CITY OF VAUGHAN

10. NEW CONSTRUCTION – SINGLE DETACHED DWELLING, 77 CLARENCE STREET, WOODBRIDGE HERITAGE CONSERVATION DISTRICT

Committee of the Whole Report

TITLE: NEW CONSTRUCTION – SINGLE DETACHED DWELLING, 77 CLARENCE STREET, WOODBRIDGE HERITAGE CONSERVATION DISTRICT

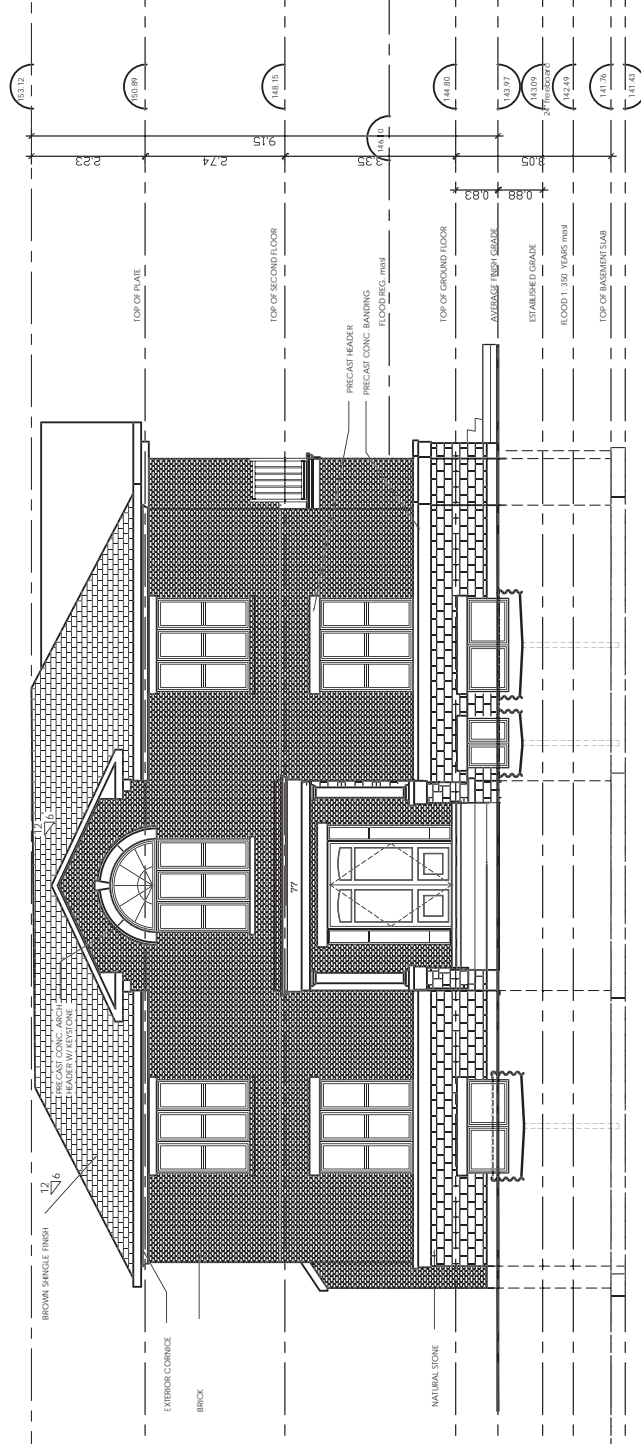
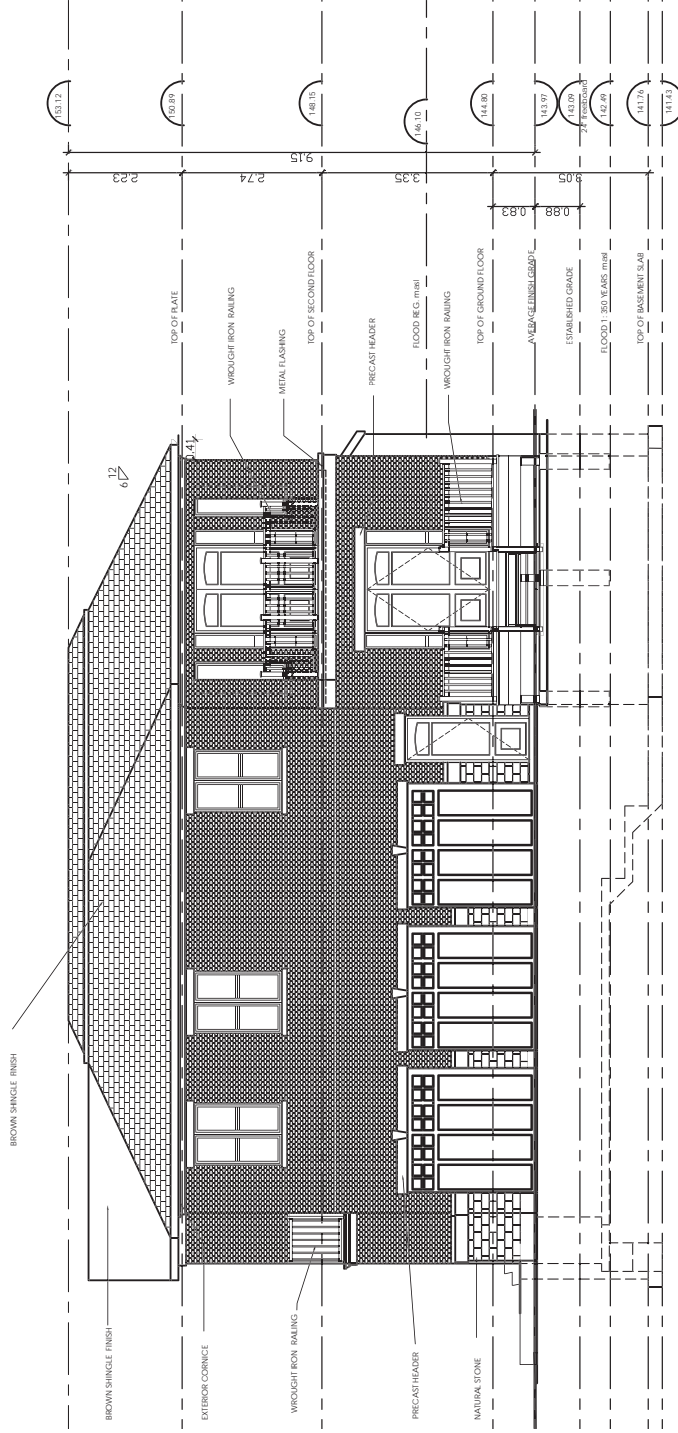
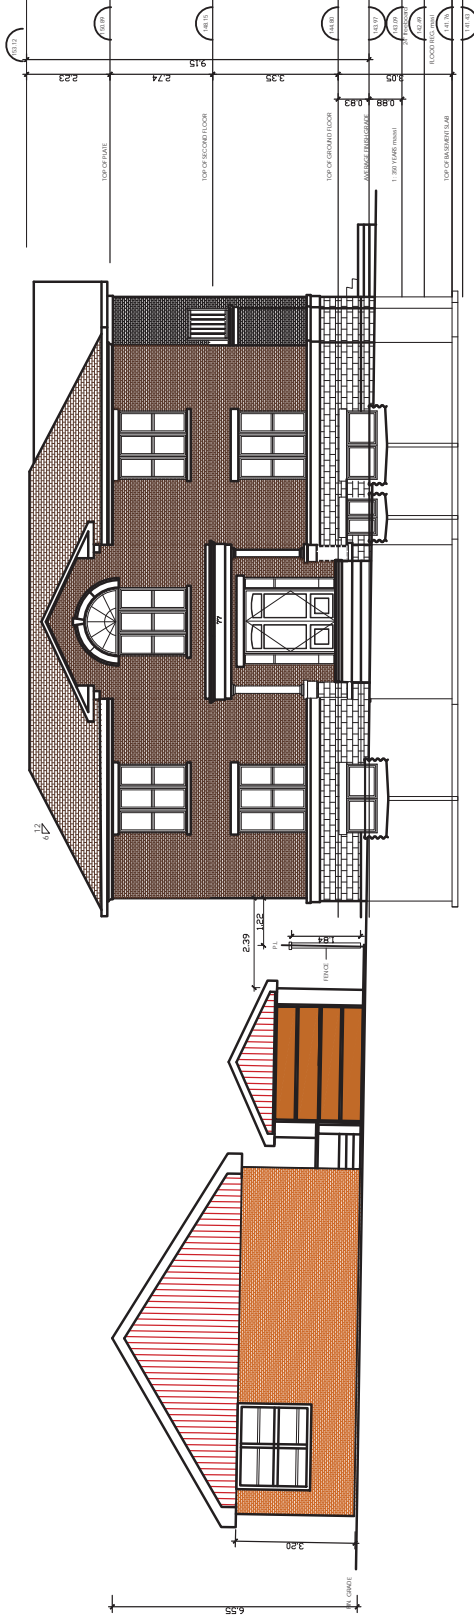
The proposed building height as shown on the submitted elevations (Attachment #4) is 9.15 m from the average finished grade to the top of the flat roof. The proposed building height is under the maximum of 11 m and will be two storeys. This height is supportive of the character of Clarence Street and Park Drive, which contains a range in building heights from 1.5 - 2 storeys. The proposed building height is satisfactory to Cultural Heritage staff. This method of measurement for the building height is consistent with Guideline #3 of Section 6.4.2.1 of the WHCD Plan.
